Product Change Notification

PCN No: 2021-04-16-01
Report Date: April 16, 2021
Subject: EVE2-70A/G Display Change
EVE3-70A/G Display Change

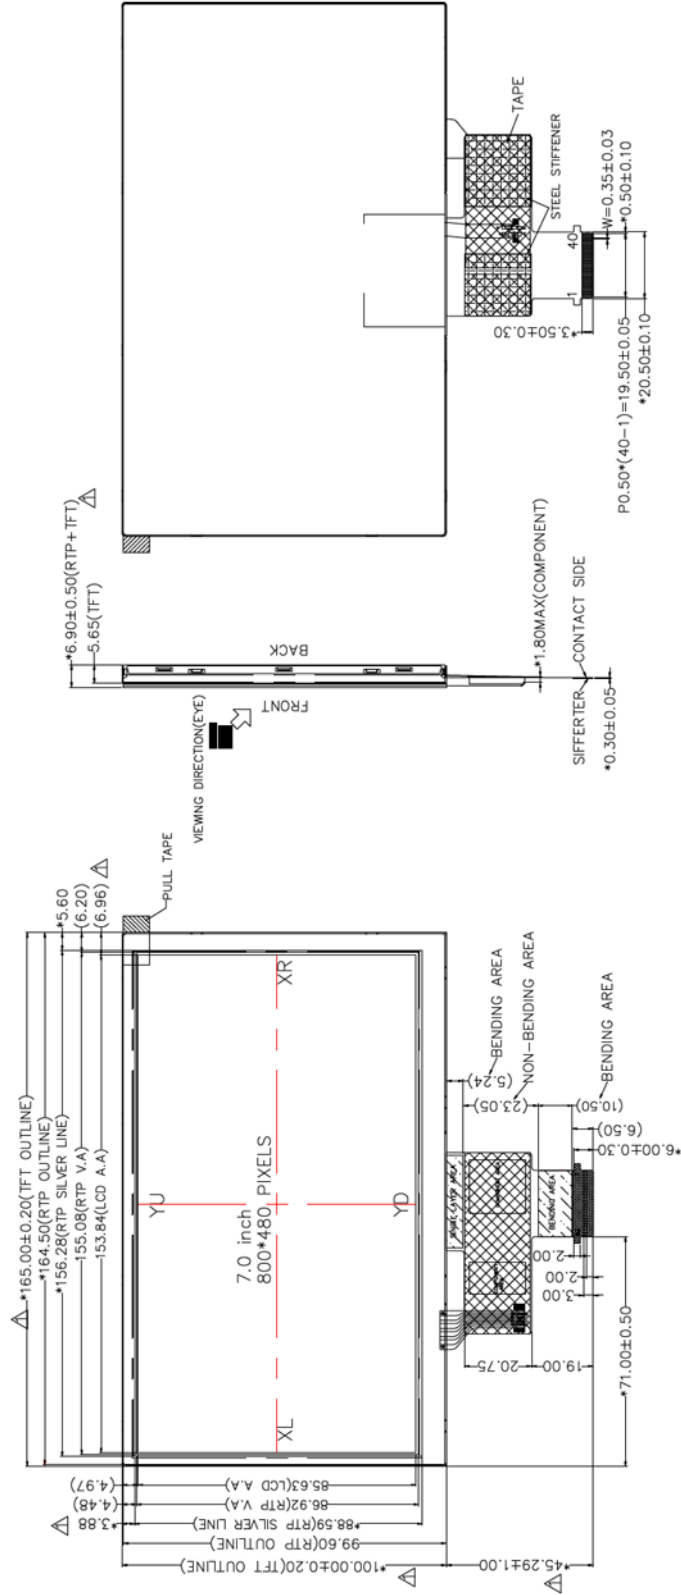
Reason for Change:
Replacement of 7.0" display panel.

Product Change:
The display mechanically has become thicker with minimal module mechanical change.

Current	New
Module size (L*W*H) mm	164.9 * 100.0 * 3.5	165.0 * 100.2 * 5.6
Active area (L*W)	153.84 * 85.63	153.84 * 85.63
Pixel pitch (L*W)	0.192 * 0.178	0.192 * 0.178
